# Access Compliance Report

## Public Rights-of-Way

Intersection ID: 25747	Main Street: HAMILTON_RD	Cross Street: SMITH_RD	Location: NW
ADA ID: 2630F18D48EE	Ramp Type: Perp	Initial Pass/Fail: Fail	Overall Compliance: No
Severity Score: 25			
Codes/Mitigation Info/Possible Solution		Field Measurements/Component Compliance

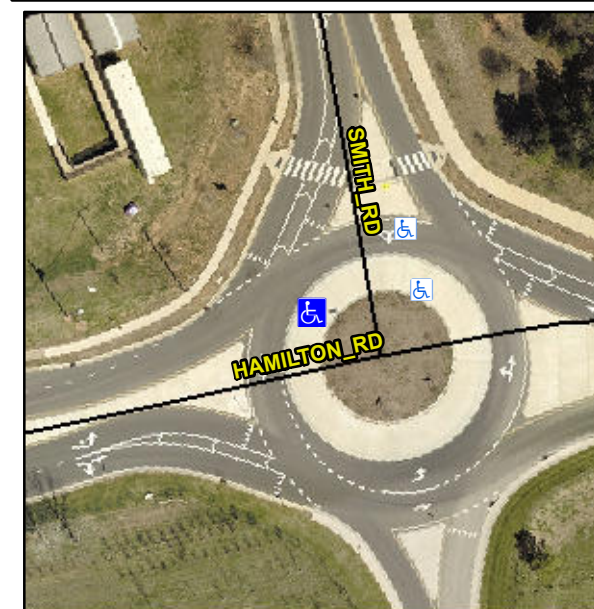
**R304.5.3**

Compliance	Description	Data	Compliance	Description	Data
N/A	Ramp Length (in)	96.0	Yes	Ramp Slope (%)	6.0
Yes	Ramp Width (in)	60.0	No	Ramp XSlope (%)	8.5
N/A	Flare Type LT	N/A	N/A	Flare Type RT	N/A
N/A	Flare Slope LT (%)	N/A	N/A	Flare Slope RT (%)	N/A
N/A	Flare Traversable LT?	N/A	N/A	Flare Traversable RT?	N/A
N/A	Landing Length (in)	N/A	N/A	DWS Provided?	N/A
N/A	Landing Width (in)	N/A	N/A	DWS Contrast?	N/A
N/A	Landing Slope (%)	N/A	N/A	DWS Length (in)	N/A
N/A	Landing X Slope (%)	N/A	N/A	DWS Full Width?	N/A
N/A	Landing Curb? (Y/N)	N/A	N/A	DWS Offset (in)	N/A
N/A	Shared Landing?	N/A			
N/A	Gutter Ponding?	N/A	N/A	Gutter Slope (%)	N/A
N/A	Gutter Lip Ht (in)	N/A	N/A	Gutter X Slope (%)	N/A
N/A	Painted X Walk1?	Yes	N/A	Painted X Walk2?	N/A
	X Walk 1 Direction	To SE		X Walk 2 Direction	N/A
N/A	X Walk 1 Width (in)	120.0	N/A	X Walk 2 Width (in)	N/A
	X Walk 1 Slope (%)	1.7		X Walk 2 Slope (%)	N/A
	X Walk 1 X Slope (%)	4.6		X Walk 2 X Slope (%)	N/A

**Remove & Replace Entire Ramp.**
